EVALUATION OF COOK IPE/HRA MATERIALS

Letter Report to U.S. Nuclear Regulatory Commission
Office of Nuclear Regulatory Research

EVALUATION OF COOK IPE/HRA MATERIALS

1. pp 41-43, R. Operator Fails to Restore Control Air Through Use of the Plant Air Compressor During Loss of Offsite Power:

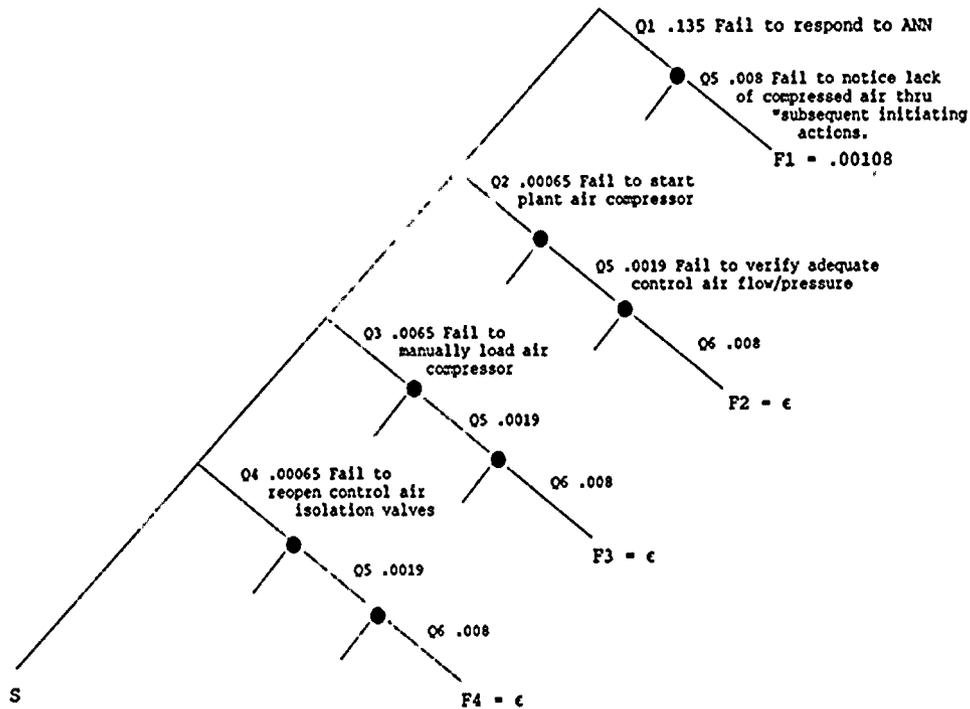
a. It is difficult to envision the human actions in the equation for the HEP. It would be much easier for a reviewer, especially one with a human factors background or one used to the THERP HRA method, to employ an HRA event tree.

b. Following is a sketch of an approximate HRA event tree in which only the failure limbs are completely drawn. One can note that each failure path through this series system ends with a potent error recovery factor (RF HEP = $8E-3$). The Q6 error is: "Operator fails to notice lack of compressed air through subsequent mitigating actions (i.e., additional valves will not open)." I don't have sufficient information to evaluate this RF, but it does result in a substantial reduction in F_T , the total failure probability for this event. Note that were it not for this RF HEP being ANDed with Q1 in the first failure path through the HRA event tree, the .135 HEP for Q1 for diagnosis error would result in a total failure probability, F_T , for this event being a factor of 125 higher.

- c. There are several misapplication of the HRA Handbook in this event:
- 1) Q1 is a modification of item #4 in Table 20-3 (the Nominal Diagnosis Model), but the nominal HEP is modified for the effects of stress. This table already includes the effects of stress. Finally, I find the multiplier of 0.1 needs to have believable justification. (See especially the discussion in item 9.d in Table 8-1 of Ref. 4)

- 2) Q2 uses the correct tabled HEP from the HRA Handbook, but the 0.1 multiplier for "trained" is questionable. Normally, if one allows extra credit for a combination of familiarity and high skill, the lower bound of the median HEP would be used. In this case, it would be $.001/3 \sim 3E-4$. Well, that seems to work out OK, assuming the use of the lower bound can be justified. The mean HEP would then probably be around the $6.4E-4$ assessed.

- 3) Q3 sounds like an ECOM, but Table 20-7 is used as the starting point, and this table is for EOMs. I couldn't tell if this action is done in the control room or is it done outside the control room.

- 4) Q4 seems OK except for the 0.1 multiplier for training.
 - 5) Q5 seems OK except for the 0.1 training multiplier. But what directs the operator to perform this step?

- 6) Q6 like all the other terms is multiplied by 0.1 for "trained." This is certainly a convenient way of reducing estimated HEPs, but the use of such a "correction factor" across the board is questionable. Also I wonder how much time is available for this generic RF.

- 7) No dependence is assessed among any of the operator actions. This may be OK; I don't know enough about the details to judge whether it is OK or not. But typically an analyst will assess independence between EOMs for written steps in a procedure. There are exceptions, however.
